Date	Expiration	Release	Page
05.2016	05.2018	0	1(3)

CLEAN IDLE DECAL ADDITION

Prevost vehicles

Figure 1 X Series Structure, Rear View

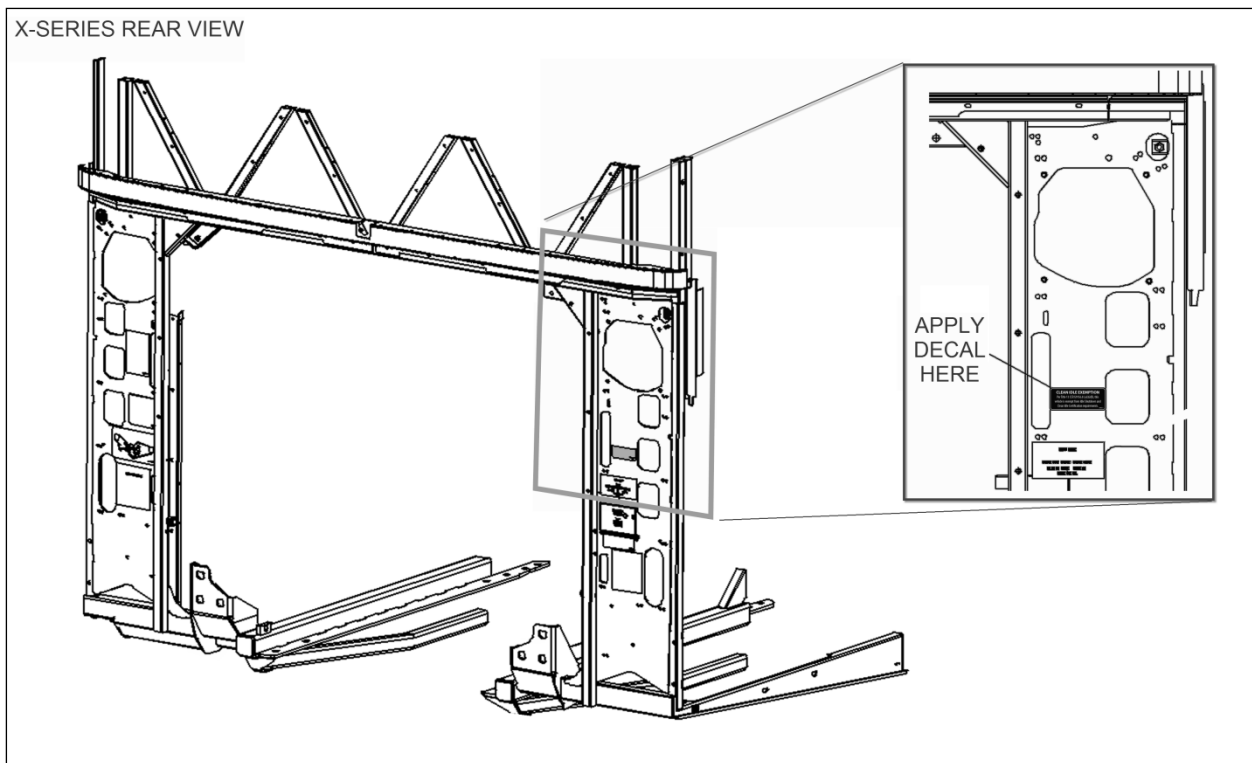
Clean vehicle structure in the indicated zone with alcohol and apply the enclosed decal #040011.
(Fig. 1 & 2)
